Response to Submissions and Amendment Report

49–61 Stephen Road, Banksmeadow

Response to ESR Banksmeadow – Submissions and Amendment
Report

Figure 2 Proposed Amended Site Plan

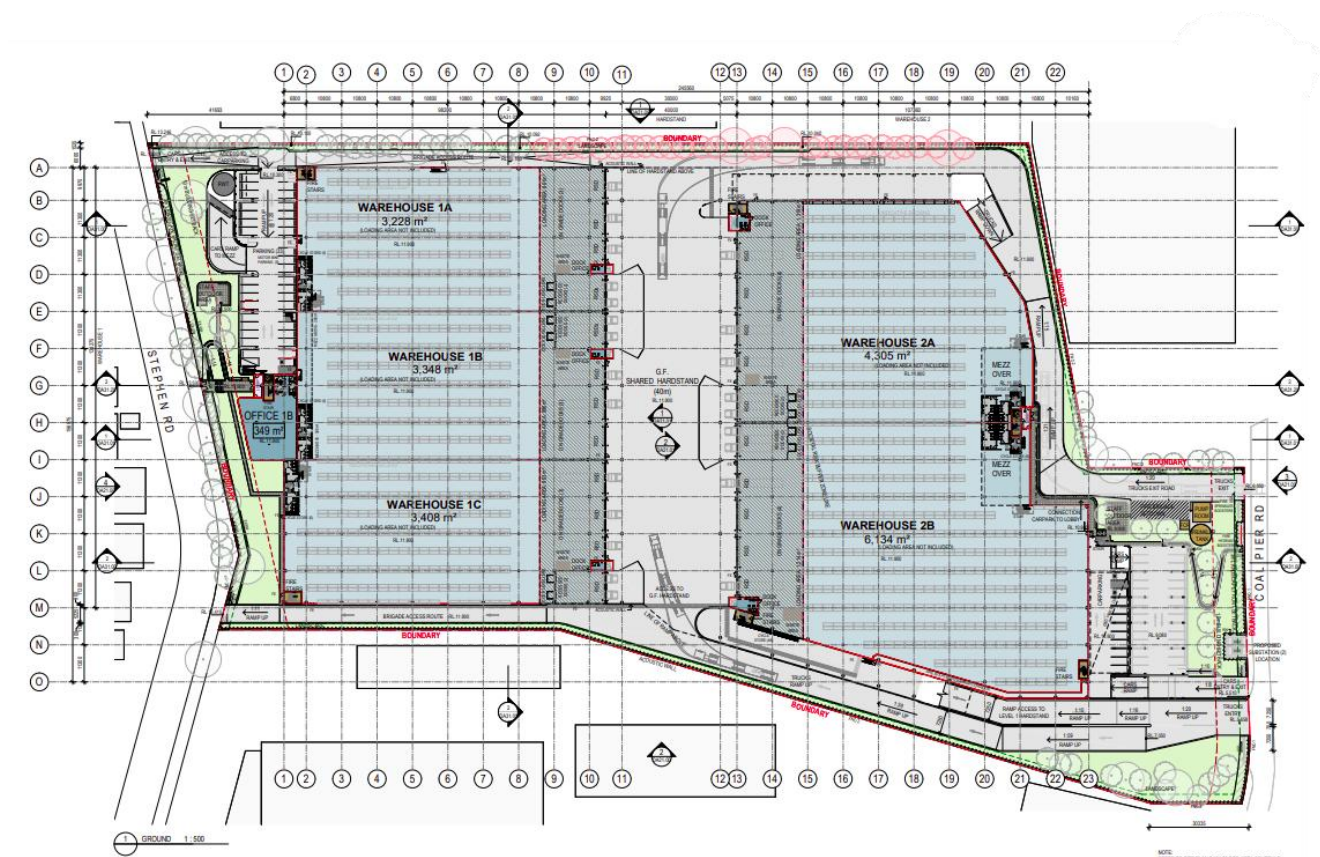
- Offices have been shifted to a dual site layout response, providing offices along the Stephen Road and Coal Pier Road frontages.
- The scheme has been reduced from three storeys to two storeys.

- The architectural materials have been revised, incorporating a brick base and horizontal articulation to reference surrounding residential forms and visually ground the buildings.

- The proposal seeks to retain existing mature street trees and boundary planting to reinforce screening and soften views of the development.

Figure 7 Proposed Site Plan

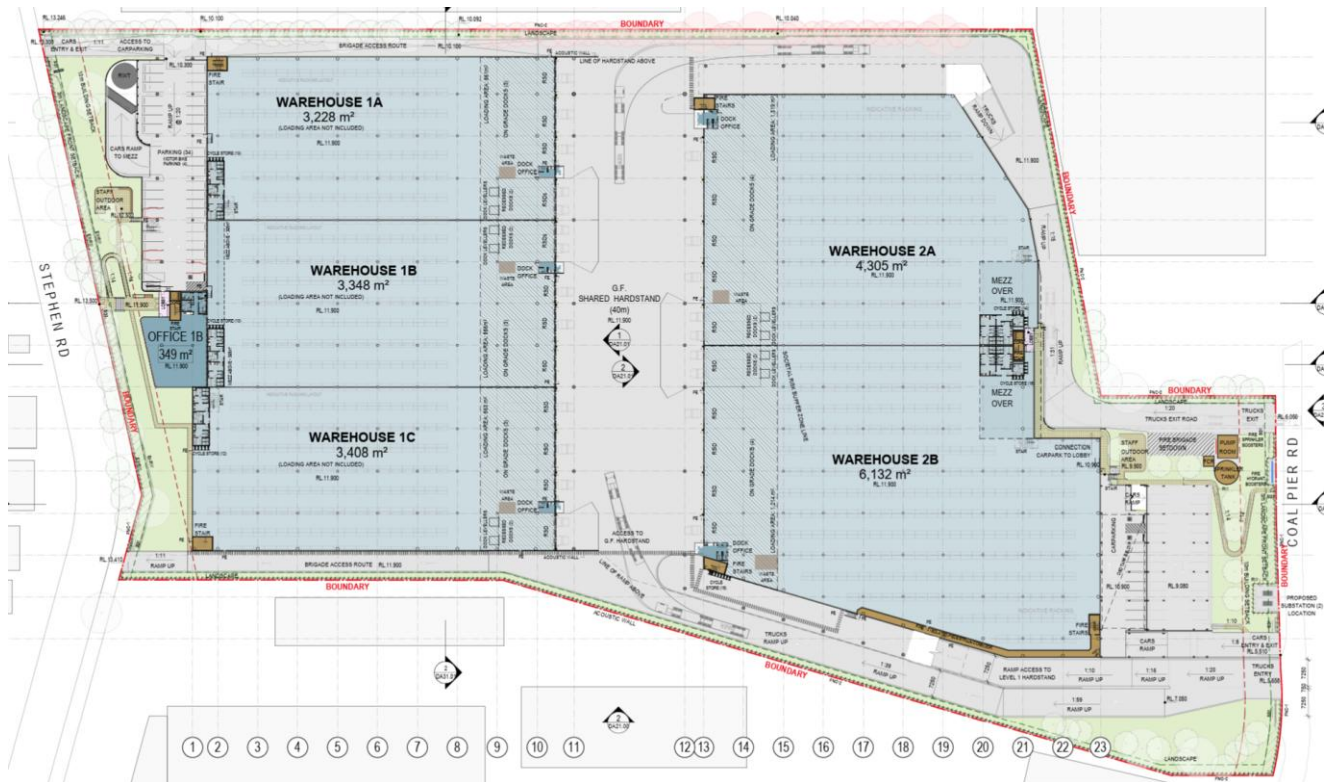
In summary, the amendments to the site layout consist of:

- Warehouse building orientation changed.
- Offices have now been split between the western and eastern building frontages to address both entrances.
- Building and landscape setbacks have been increased.
- Carpark areas have been amended to create two separate locations for access to the separate office spaces.
- The truck entry from Coal Pier Road has been shifted to the north.
- The car park entry/exit from Coal Pier Road has been shifted to the south.
- The ruck ramp has been relocated from a spiral design along the eastern boundary to the northern and southern side.
- Café removed.

Figure 8 Proposed Architectural Plans

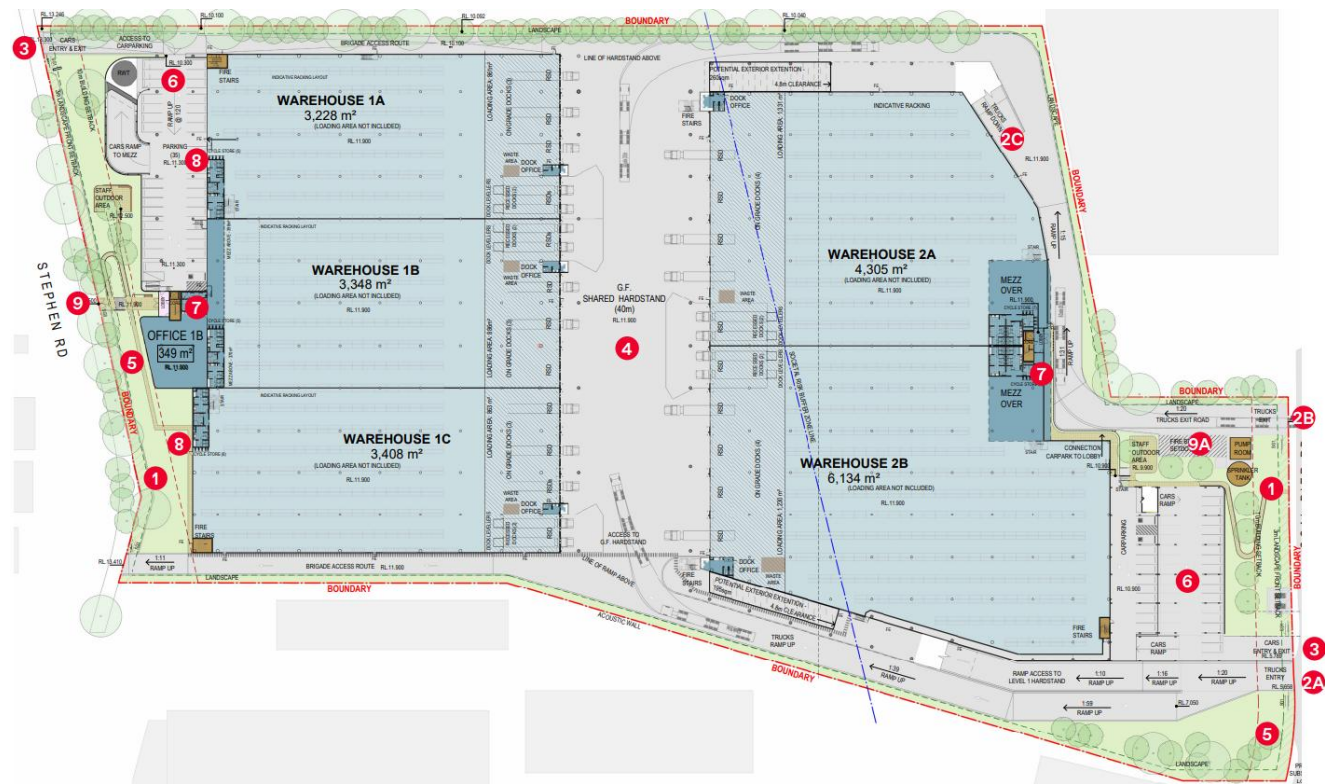
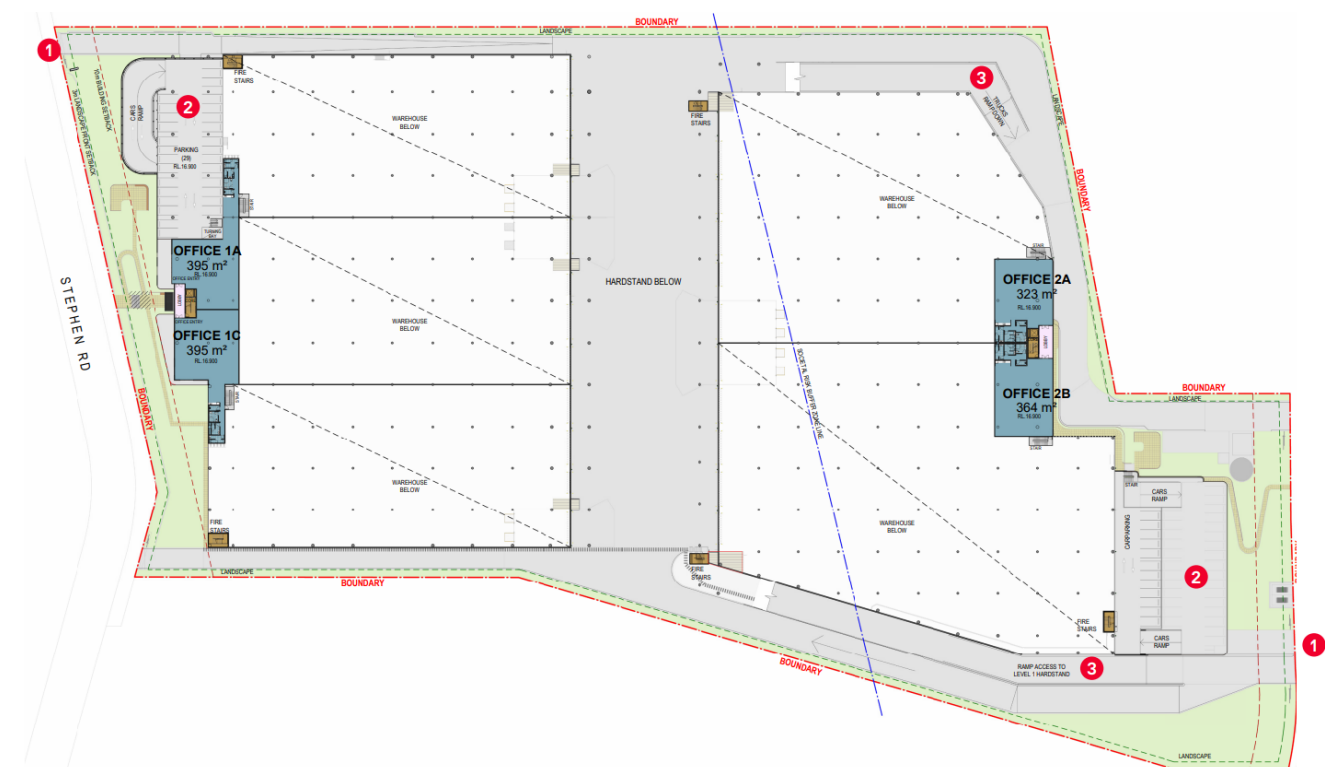
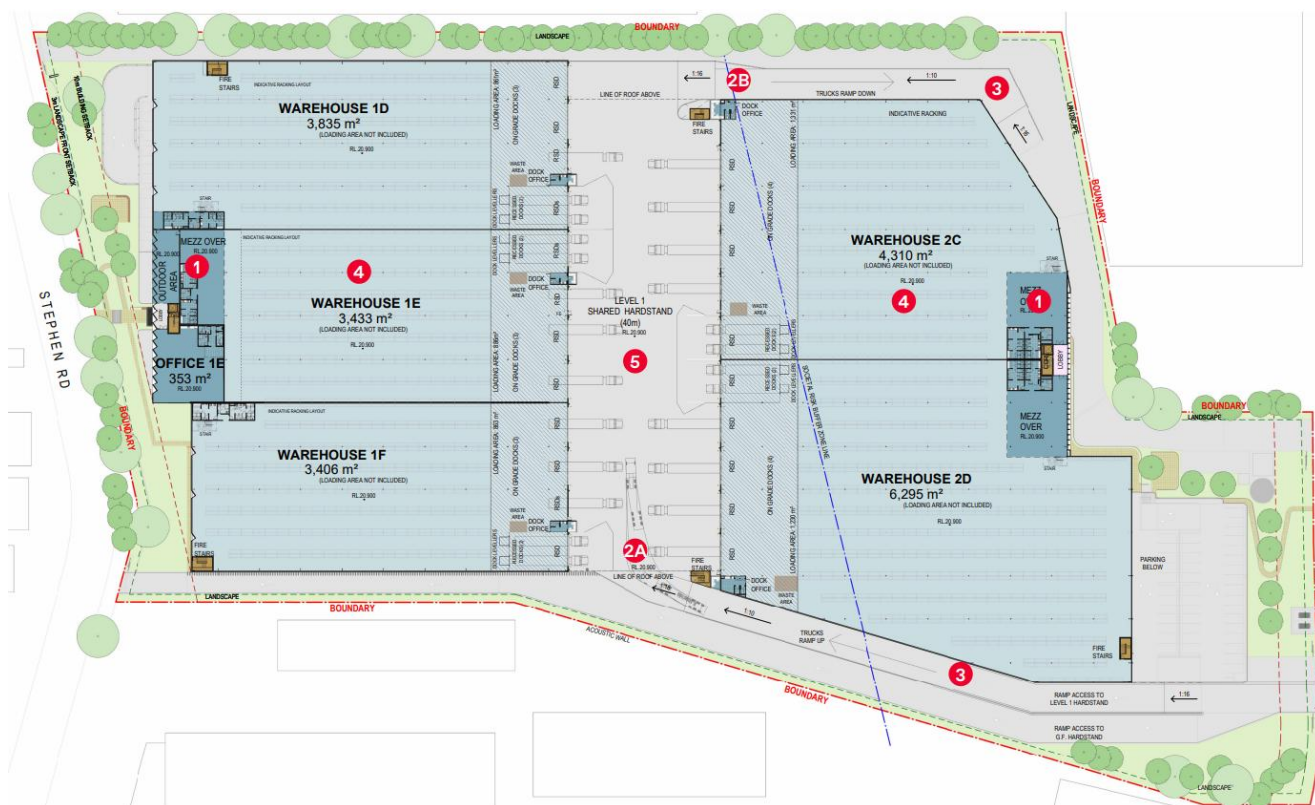
The built form and massing has been amended to achieve a 2-storey warehouse building with integrated office spaces. These will be connected by shared hardstands, with all truck entry and exit from Coal Pier Road. Separate low scale 3-storey car parking is provided with entry & exits from Stephen Road & Coal Pier Road. The design changes include:

- Reduction in building height as a result of the removal of one warehouse level.
- Internal reconfiguration of the warehouse tenancies and office blocks to reflect the change in building orientation.
- The number of tenancies and loading docks have been reduced to reflect the reduction of GFA.

Figure 10 Comparison Study of Massing

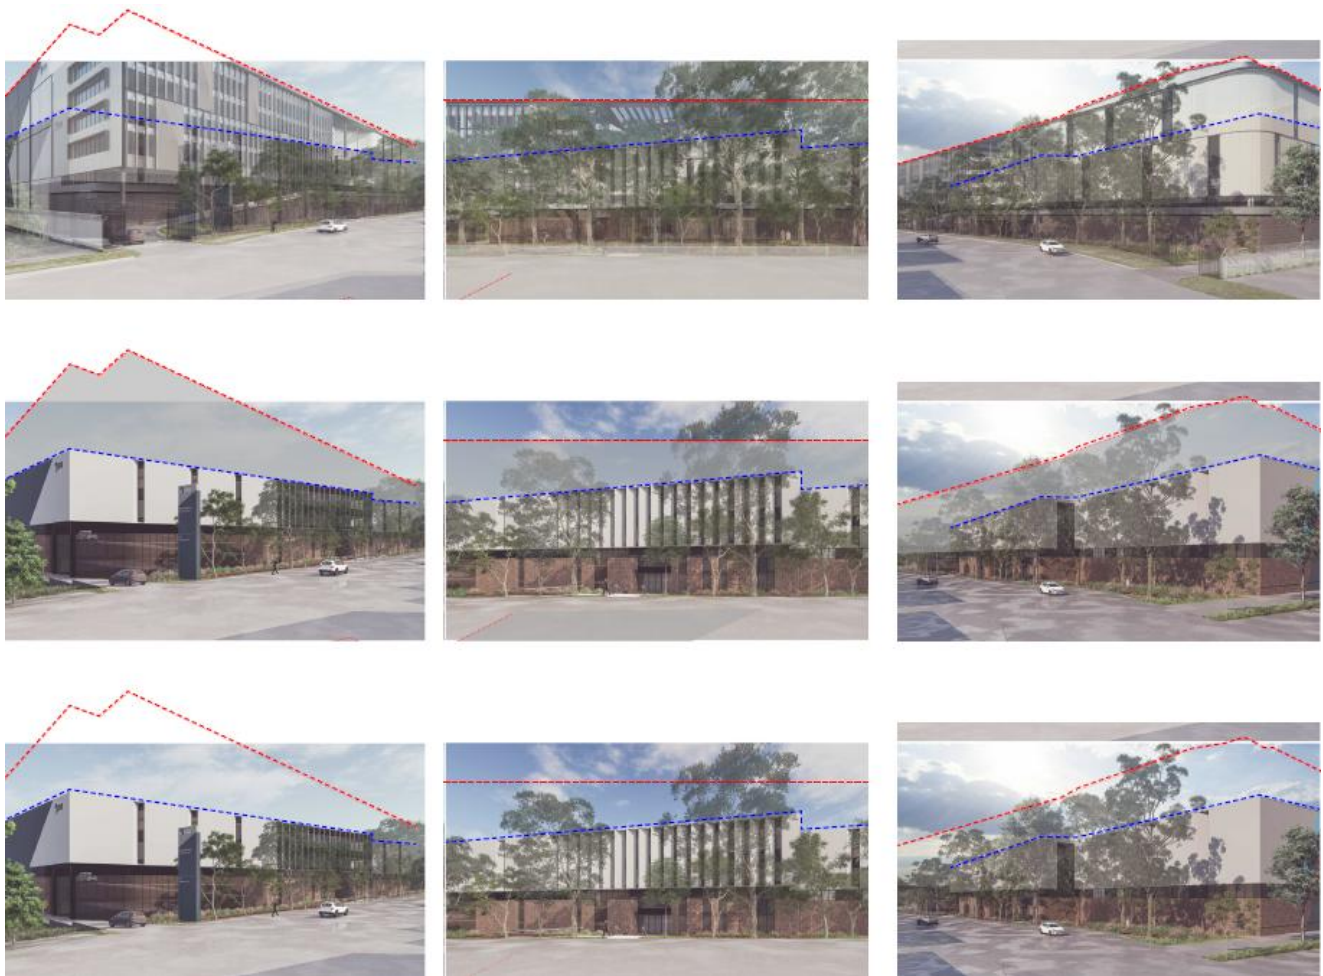
Through the design development process, the building height and upper massing was significantly reduced. In particular, the industrial multi-level warehouse has been reduced from three levels in the earlier concept to two levels in the final proposal. This adjustment significantly lowers the overall building profile and reduces the perceived scale of the development when viewed from the public domain and surrounding properties as outlined in **Figure 10** below.

**The red line denotes the previous scheme's height. The blue line denotes that of the current proposed scheme.*

Figure 14 Shadow Diagrams

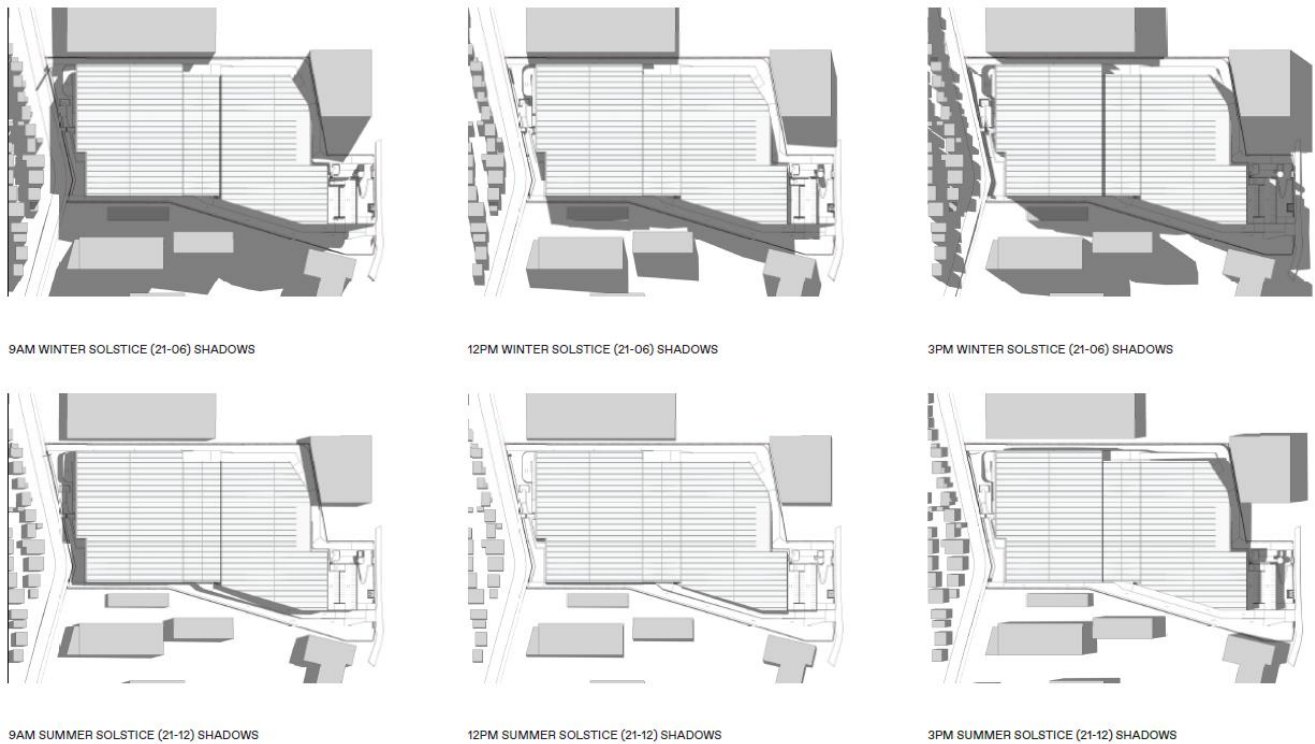
- The shadow diagrams included in the Architectural Plans demonstrate the overshadowing to surrounding properties at the summer and winter solstice. An extract is provided in **Figure 14** below which demonstrates the proposed impacts of the building on the surrounding residential properties. The diagrams show there will only be minimal impact on solar access to three residential properties' front gardens to the west during the winter solstice at 9am. The shadow only falls on these properties till 10am. There will be no impacts as a result of the proposal on any living spaces along Stephen Road. The majority of the overshadowing impacts will be focused to the industrial development located to the south of the site during the midwinter.

This solar impact is significantly reduced from the previous scheme which proposed to create shadowing across the private open spaces and potentially living spaces of residential properties located to the west.
